## **ASPECT INDUSTRIAL ESTATE STAGE 3 DEVELOPMENT (SSD-58257960) - RESPONSE TO REQUEST FOR ADDITIONAL INFORMATION WAREHOUSE 2**

This response letter has been prepared by Urbis on behalf of Mirvac Industrial Developments Pty Ltd (Mircac) (**the Applicant**) in response to various requests for additional information (**RFI**) on 20<sup>th</sup> March, 25<sup>th</sup> March and 12<sup>th</sup> April 2024 from the Department of Planning, Housing and Infrastructure (**DPHI**) in connection with the above SSD Application for Warehouse 2 at the Aspect Industrial Estate (**AIE**).

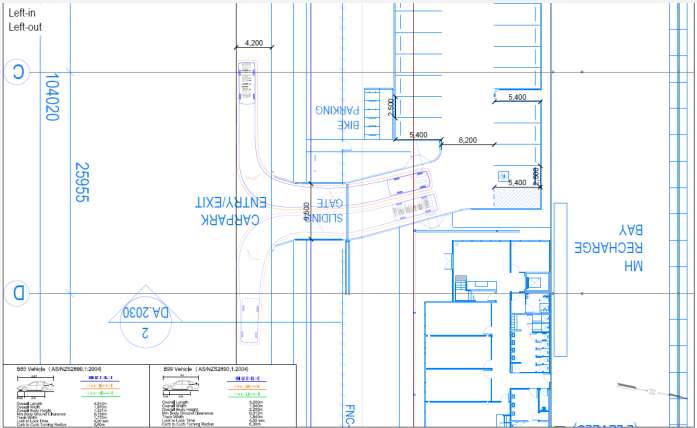
<p>Rendered images of the Warehouse 2 building are provided in the RtS report only but have not been included in the architectural drawings. Only roof and signage plans have been provided. Please provide a full set of the updated architectural drawings including site plans, floor plans, and rendered images of the Warehouse 2 building. It appears the rendered images are inconsistent with the EIS</p>	<p>See Attachment A – Updated Architectural Plans and Attachment B – CGI Renders</p> <p>See extract of CGI Renders below.</p>
